Re: 13CVCP155K
50 Greenpoint Avenue
Brooklyn, NY
Remedial Action Work Plan (RAWP) Stipulation List

Environmental Business Consultants (EBC or the consultant) hereby submits a Remedial Action Work Plan (RAWP) Stipulation List for the 50 Greenpoint Avenue (the Site) to the New York City Office of Environmental Remediation (OER) on behalf of Euro Builders. This letter serves as an addendum to the RAWP to stipulate additional content, requirements, and procedures that will be followed during the Site remediation. The contents of this list are added to the RAWP and will supersede the content in the RAWP where there is a conflict in purpose or intent. The additional requirements/procedures include the following Stipulation List below:

FIGURE 6 Endpoint Sampling Plan

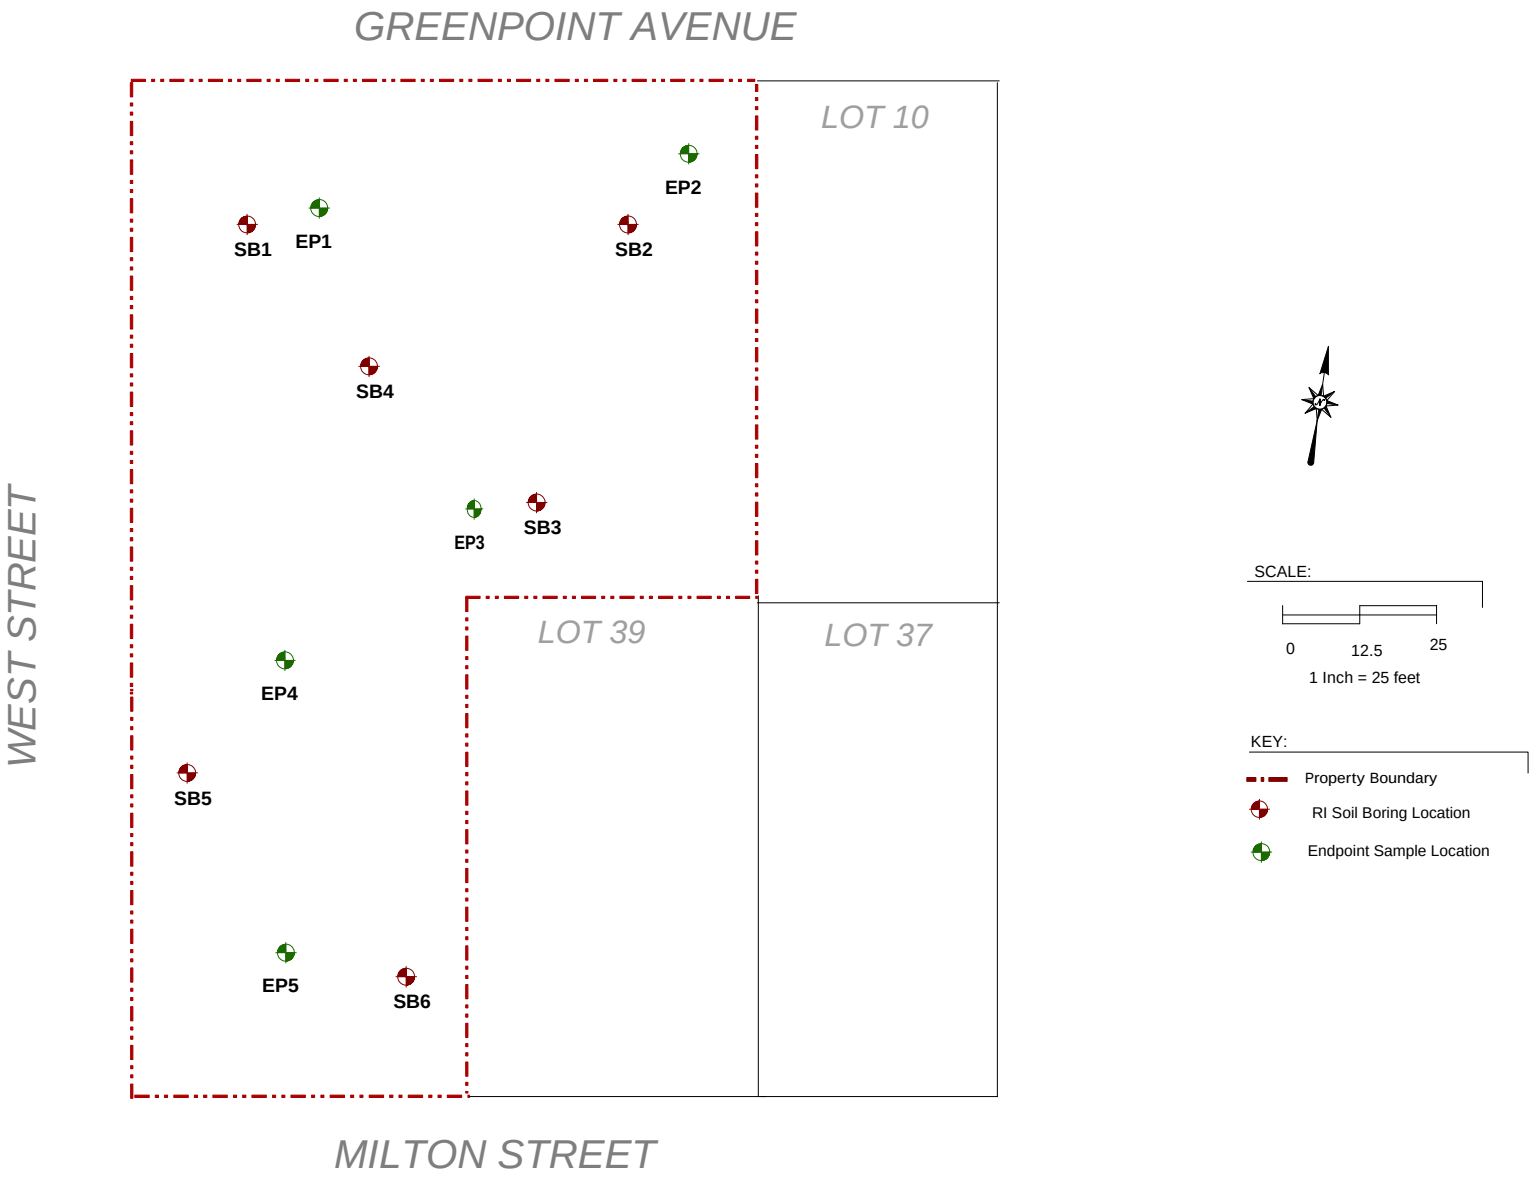
8. Collection and analysis of five post-excavation samples from the bottom of the excavation will be collected to evaluate the performance of the remedy with respect to attainment of Track 1 SCOs. Figure 6 indicating End point post-excavation sampling locations is attached in **Appendix 3**. Samples will be analyzed for contaminants of concern (VOCs, SVOCs, and TAL Metals).

FIGURE 1 TRUCK ROUTES

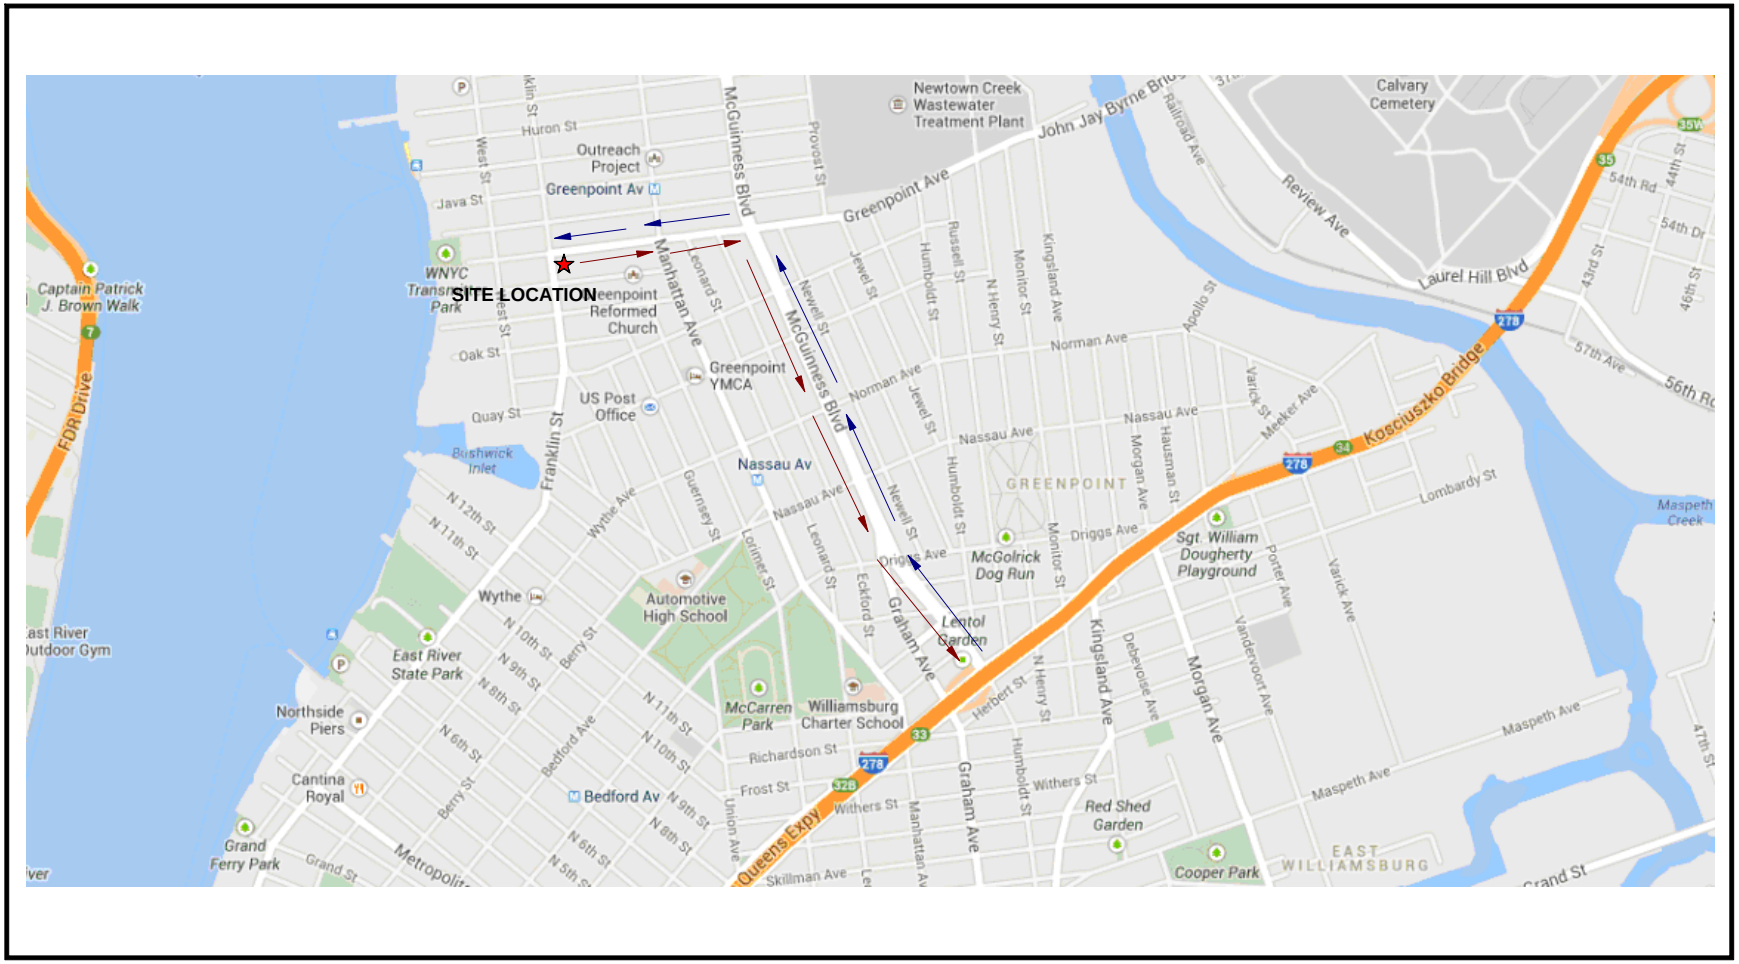
9. Truck route is included in **(Appendix 4**).
